MILLSTONE NUCLEAR POWER STATION, UNIT NO. 2

Amendment No. 18  
License No. DPR-65

ATTACHMENT TO LICENSE AMENDMENT NO. 18

SAFETY EVALUATION BY THE OFFICE OF NUCLEAR REACTOR REGULATION  
SUPPORTING AMENDMENT NO. 18 TO FACILITY OPERATING LICENSE NO. DPR-65

FIGURE 3.2.4  
AXIAL SHAPE INDEX Operating Limits with 4 Reactor Coolant  
Pumps Operating

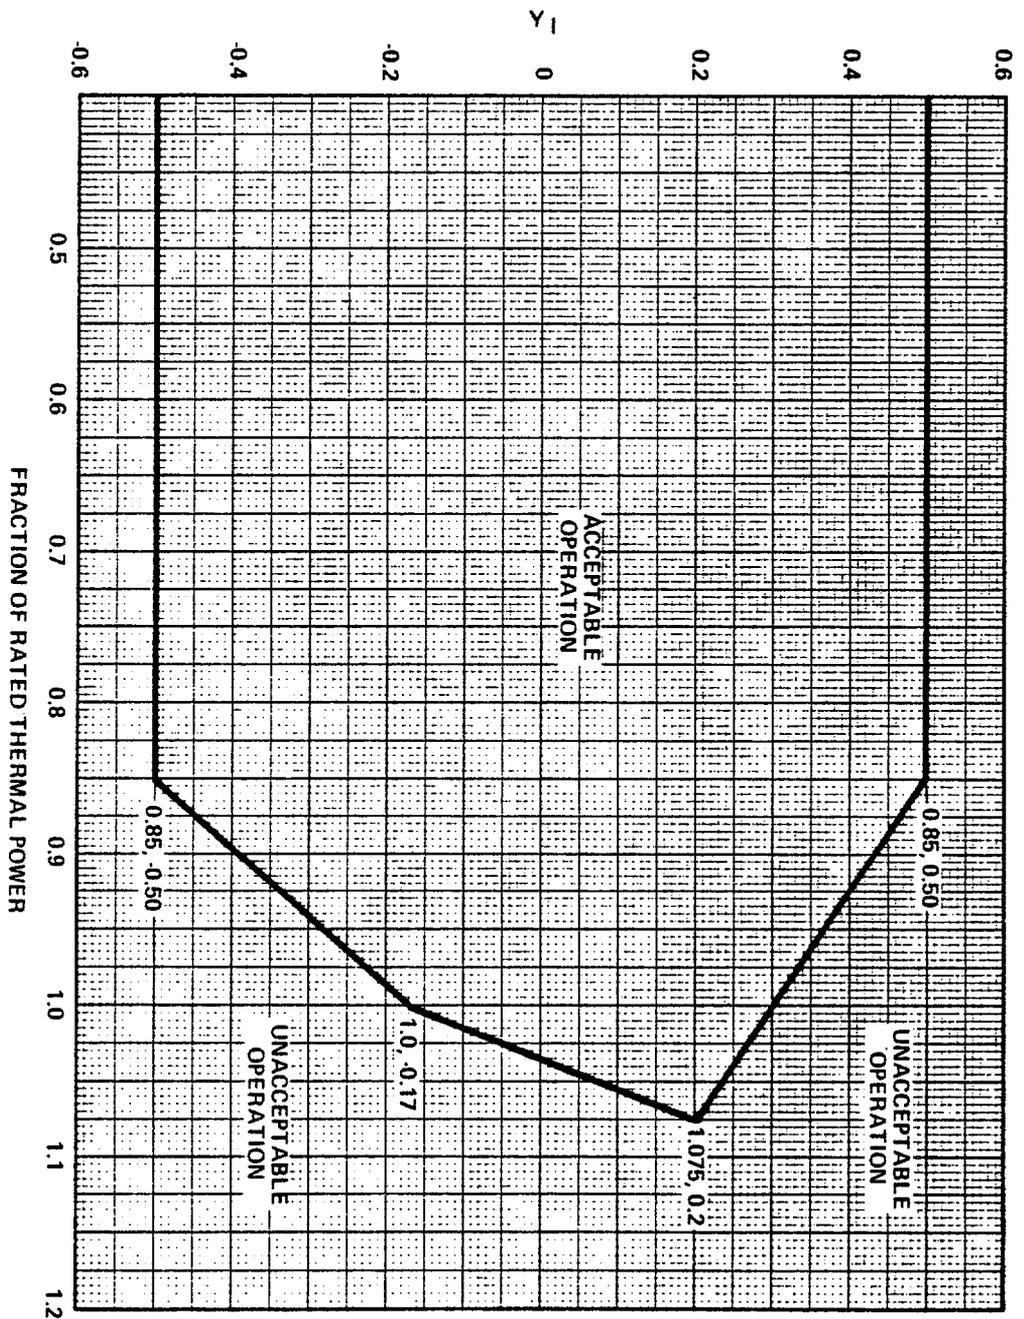
The amendment will change the Technical Specifications for the Reactor Coolant Flow-Low reactor trip and the axial shape index operating limits.

Lowering the reactor trip setpoint for Reactor Coolant Flow-Low from  $\geq 95\%$  to  $\geq 91.7\%$  of reactor coolant flow would yield a significant reduction in DNBR as a result of an electrical or a mechanical reactor coolant pump failure. Consequently, to compensate for this potential reduction in DNBR, NNECO also proposed to operate within a more restrictive Axial Shape Index. By adopting the more restrictive Axial Shape Index, the enthalpy in the coolant channel within the core that produces the highest relative enthalpy rise (limiting  $F_{\Delta h}$ ) is lowered. This lowering of local enthalpy rise in the

hot channel results in a minimum DNBR which is higher at the beginning of an incident than would be the case with a less restrictive Axial Shape Index.

The amendment will change the Technical Specifications in response to the licensees' application dated May 17, 1976 to decrease the reactor coolant low-flow trip set point of the reactor protective system from  $\geq 95\%$  to  $\geq 91.7\%$  and to make the Axial Shape Index operating limits more restrictive. The decrease in the low-flow trip set point will be partially offset by operating within the more restrictive Axial Shape Index. The remainder of the decrease will be offset by allowing the DNBR for the loss of flow transient to decrease from a minimum of 1.34 to a minimum of 1.30 and by allowing the percent of the core experiencing a DNBR less than 1.30 for the seized rotor accident to increase from 0.42% to about 0.5%.

<u>Parameter</u>	<u>LIMITS</u> Four Reactor Coolant Pumps Operating
Cold Leg Temperature	$\leq 544^{\circ}\text{F}$
Pressurizer Pressure	$\geq 2225 \text{ psia}^*$
Reactor Coolant Flow Rate	$\geq 370,000 \text{ gpm}$
AXIAL SHAPE INDEX	Figure 3.2-4
